# MARCO POLO - 101 W 33RD STREET

Date	Description
05.19.2022	Progress Set

3 RCP - 3RD FLOOR  
1" = 10'-0"

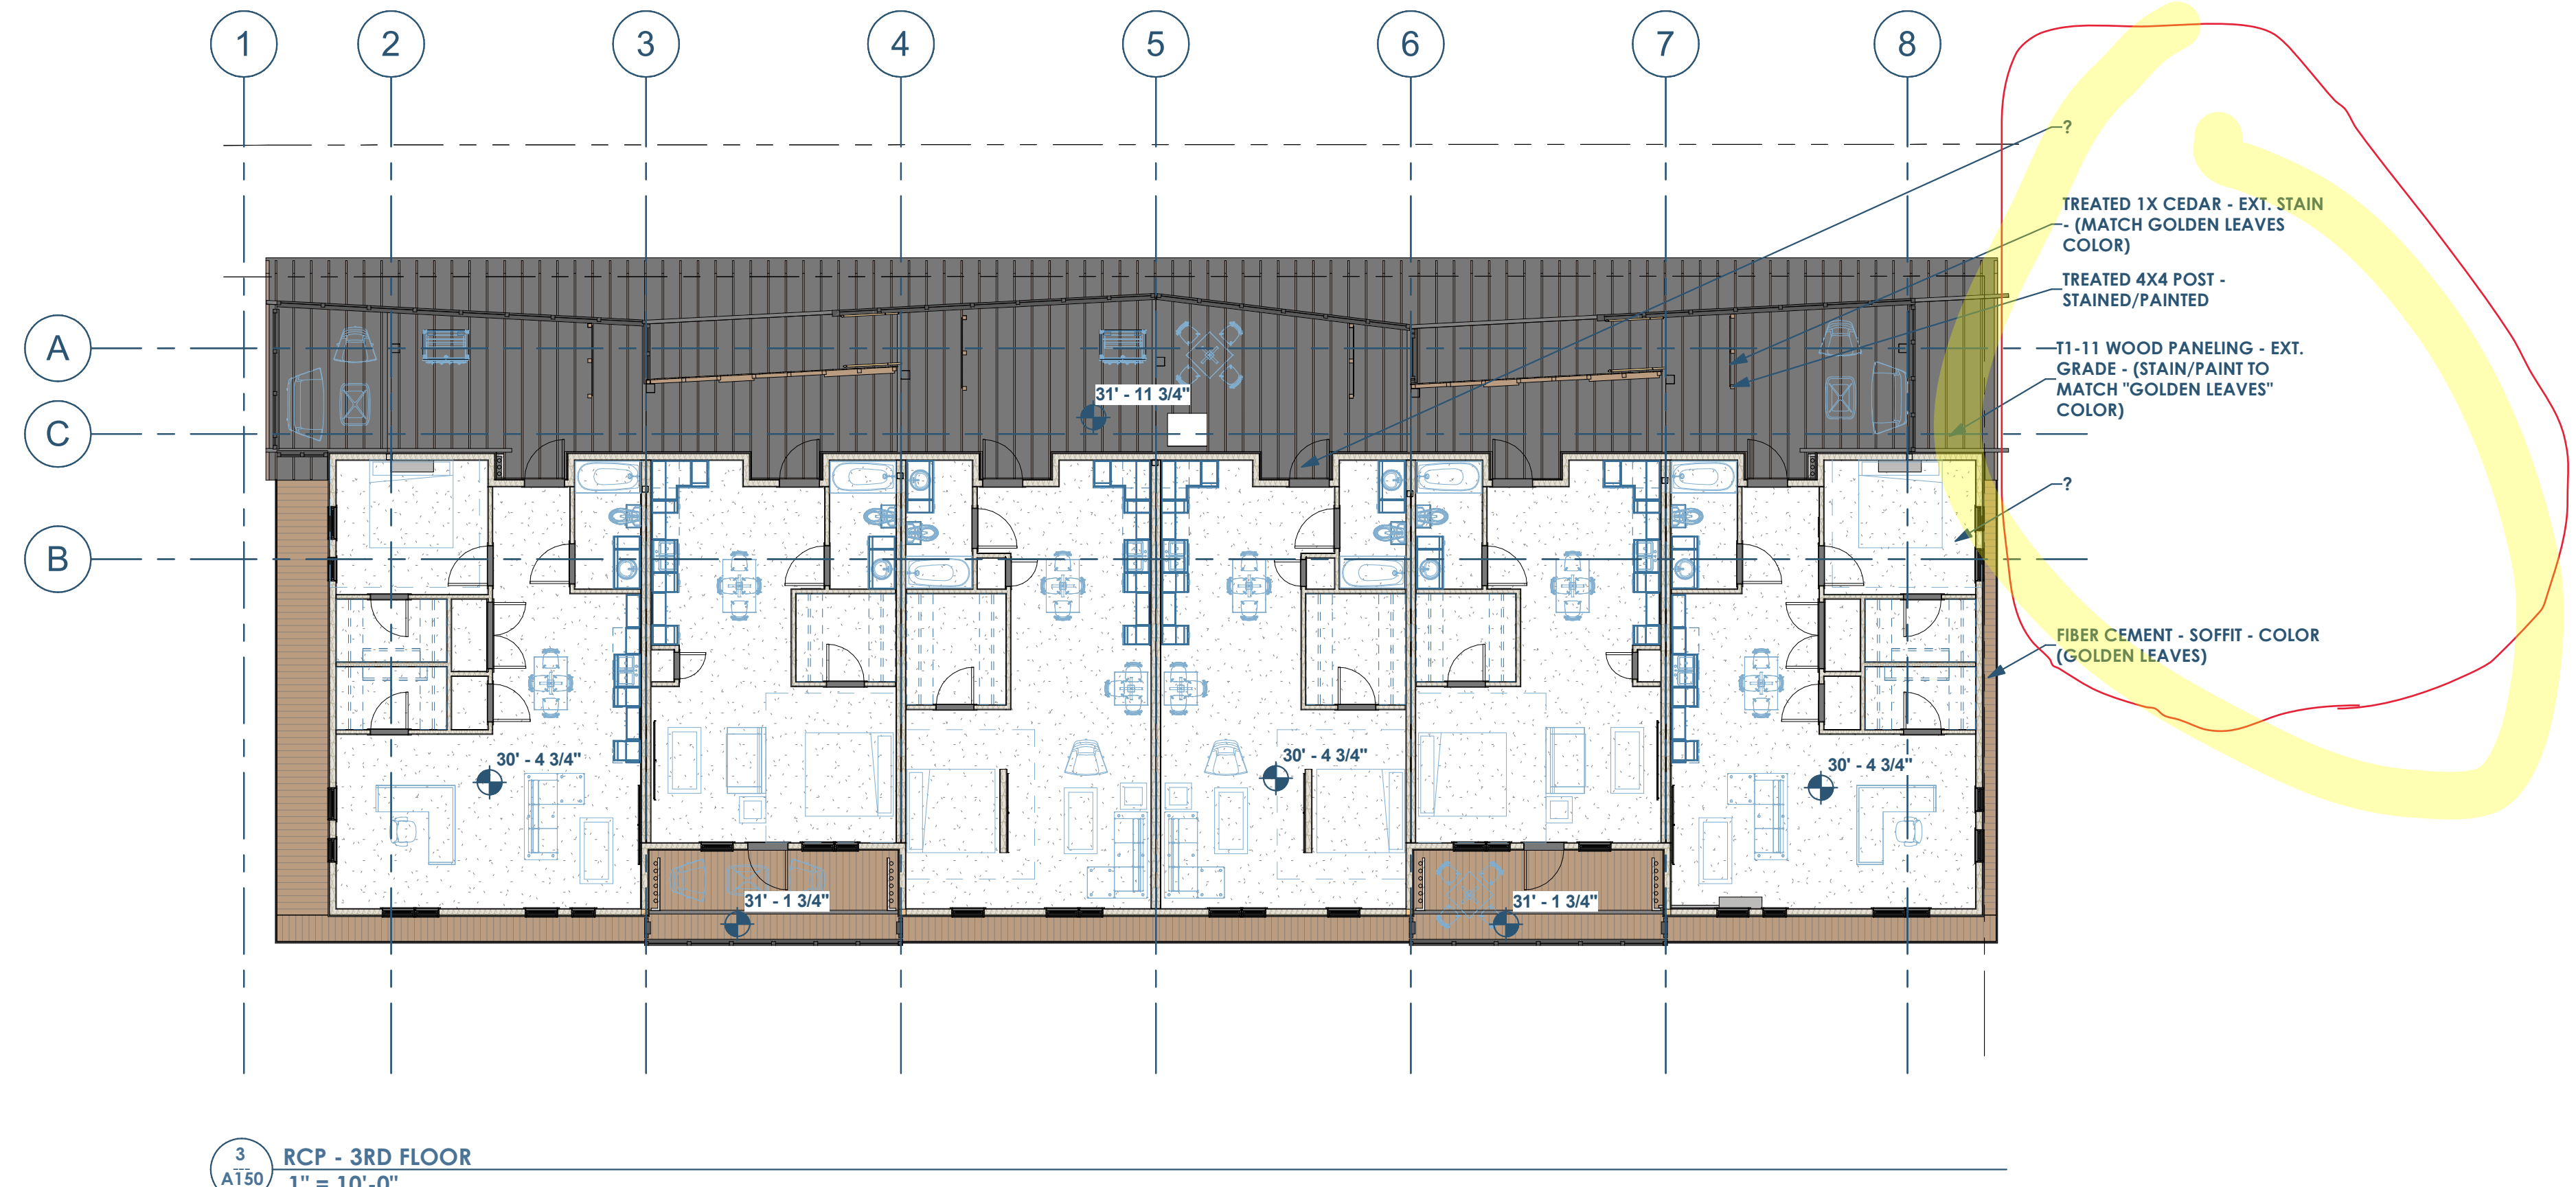
THESE NOTES DON'T REFERENCE THE RCP AND DON'T BELONG ON THIS SHEET.  
FURNITURE AND DOORS SHOULD NOT BE SHOWN ON RCP.

WE NEED TO ID THE CEILING MATERIAL AND SHOW LOCATIONS AND TYPES OF LIGHT FIXTURES.

5A A300 BUILDING SECTION - THROUGH STAIRS - LOOKING SOUTH  
3/16" = 1'-0"

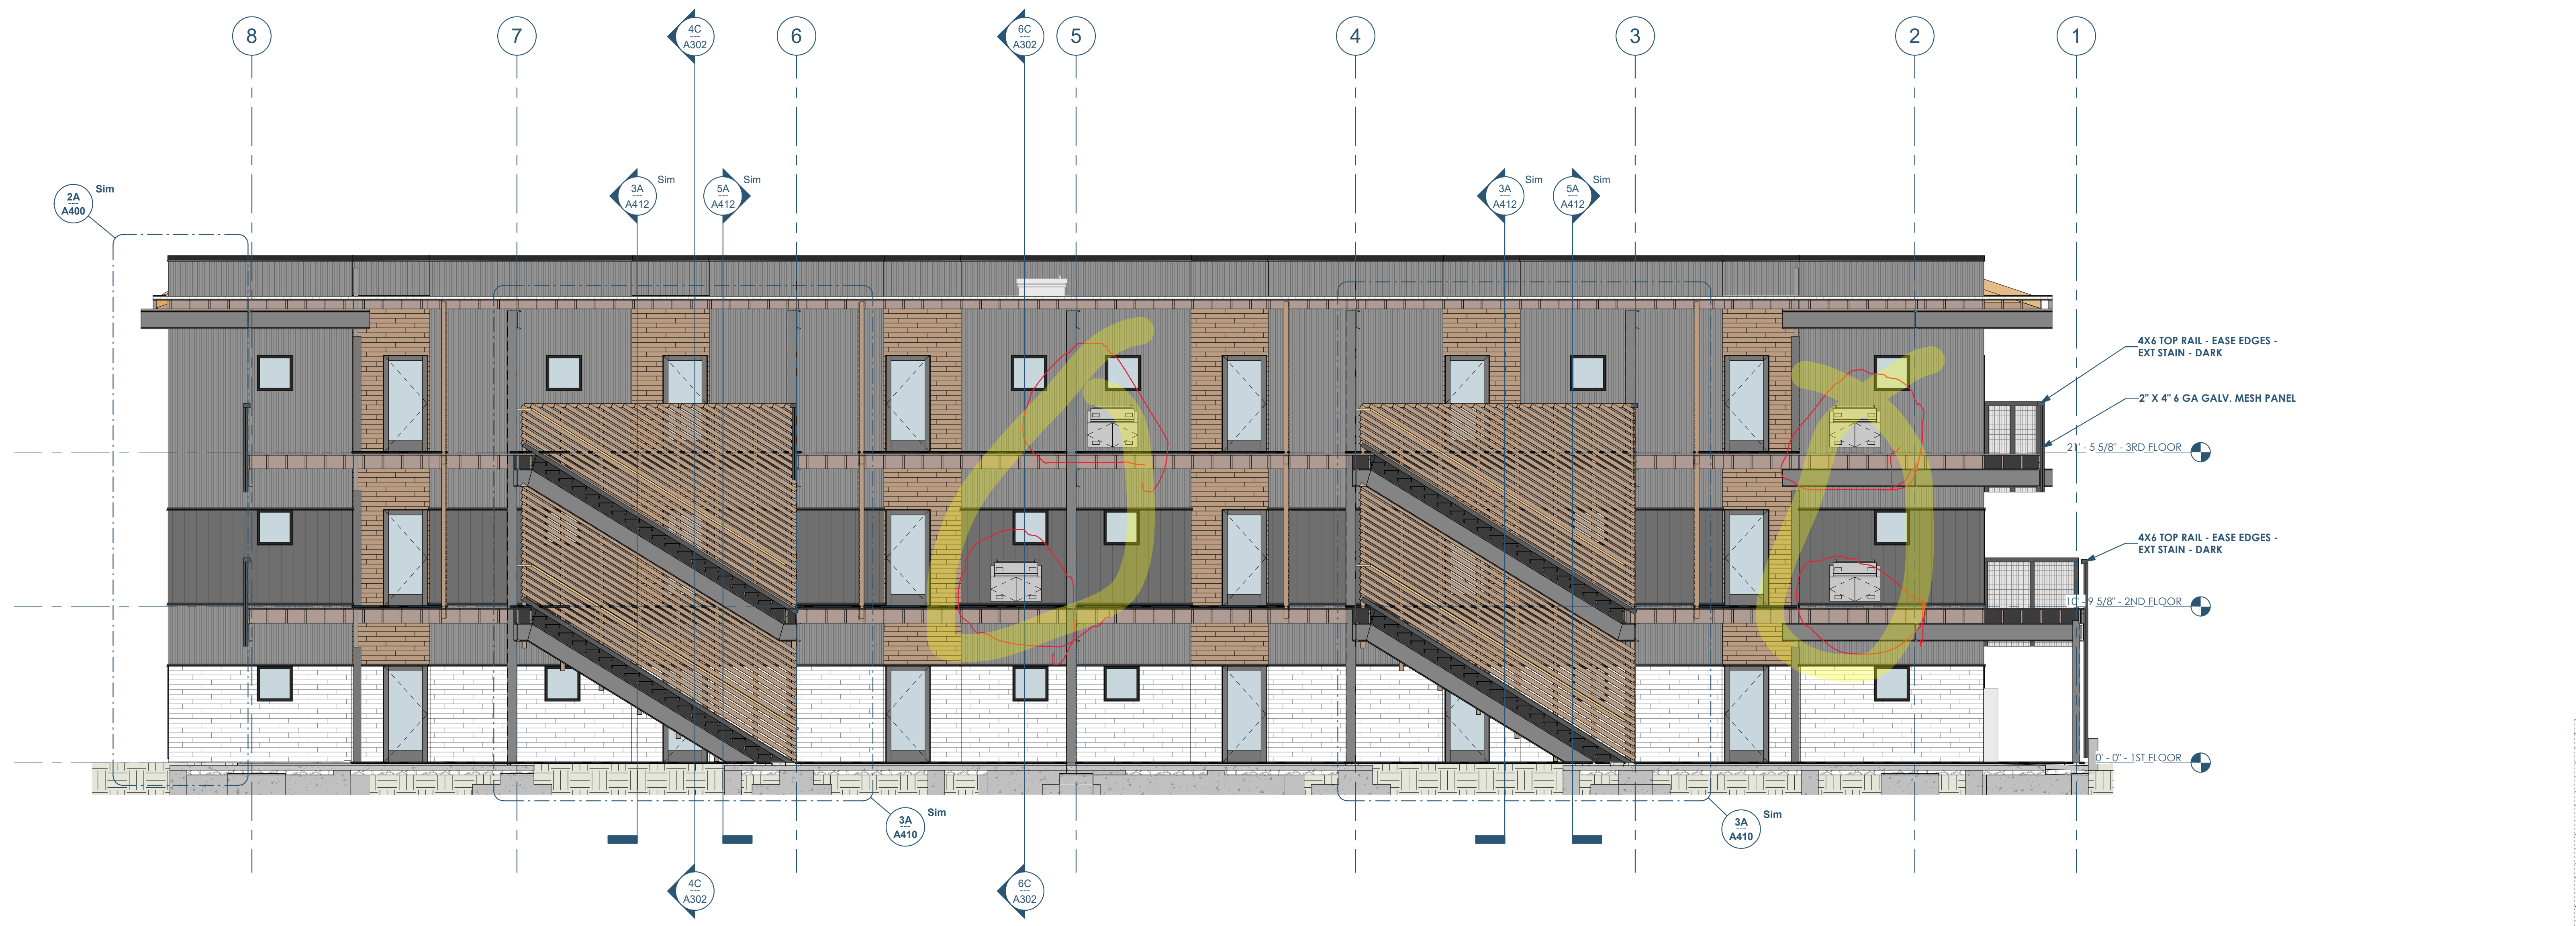
HIDE ANY EQUIPMENT THAT OWNER IS NOT PROVIDING.
